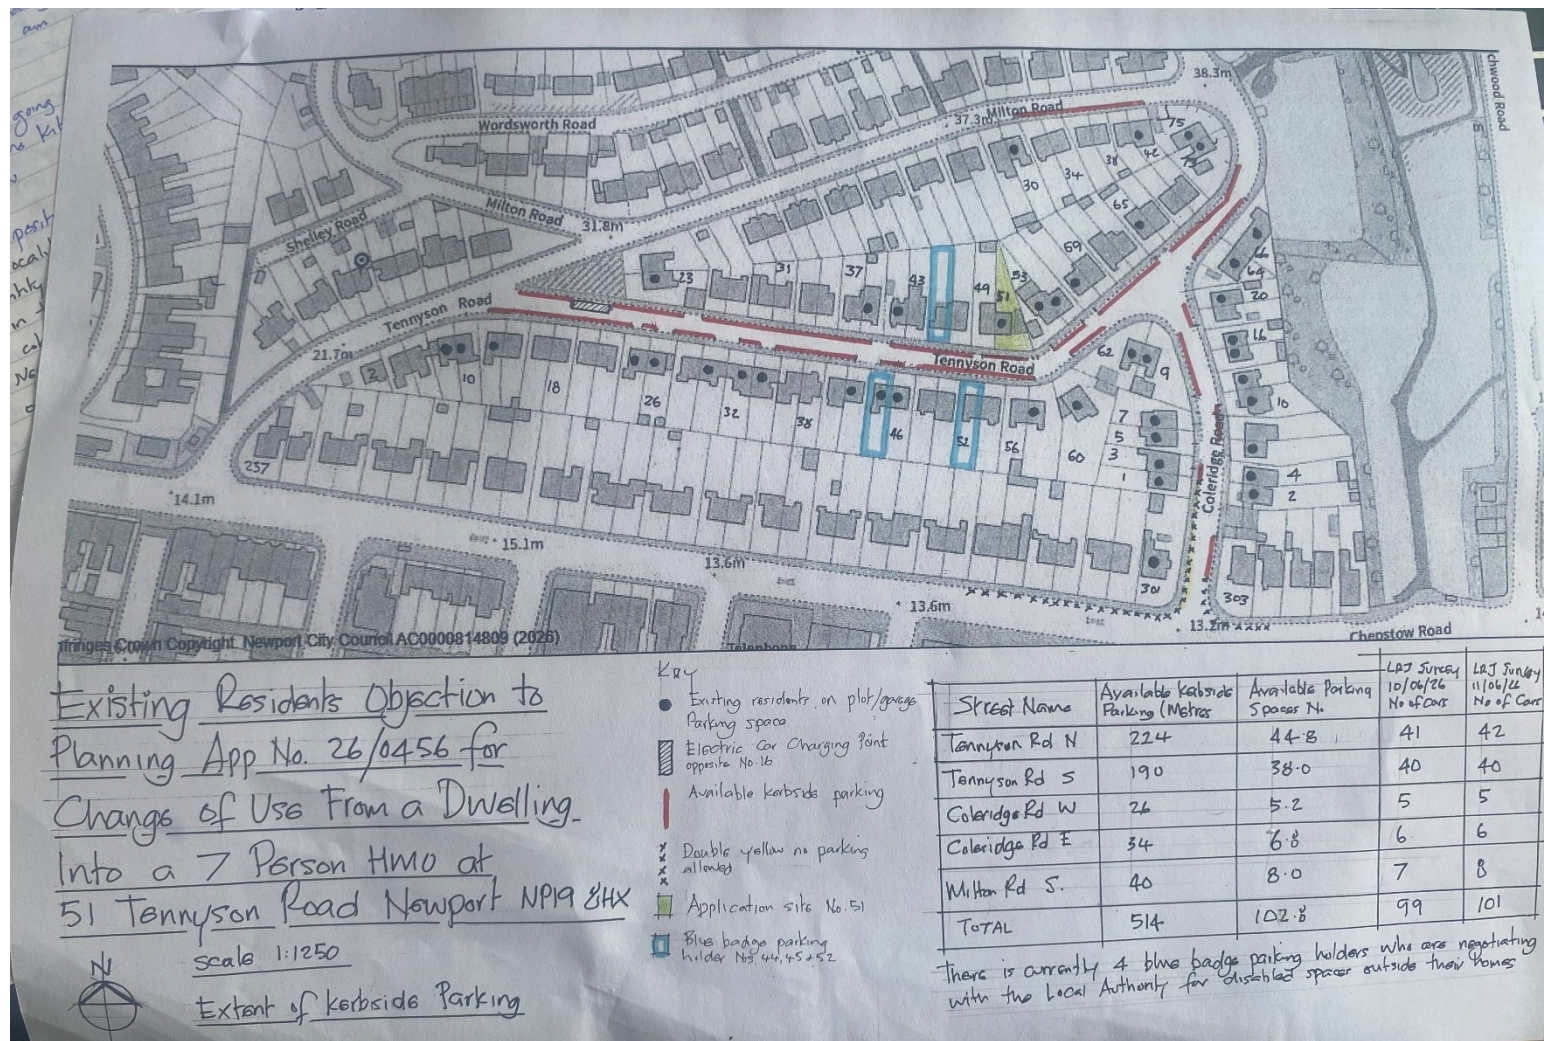
The actual amount of available kerbside parking is 514 metres (not 564 in the applicant's submitted survey) as demonstrated on the plan above. Electric vehicle charging points need to be taken into account as well as allocated blue badge parking spaces and vehicular accesses to drives – these are demonstrated on the plan above.
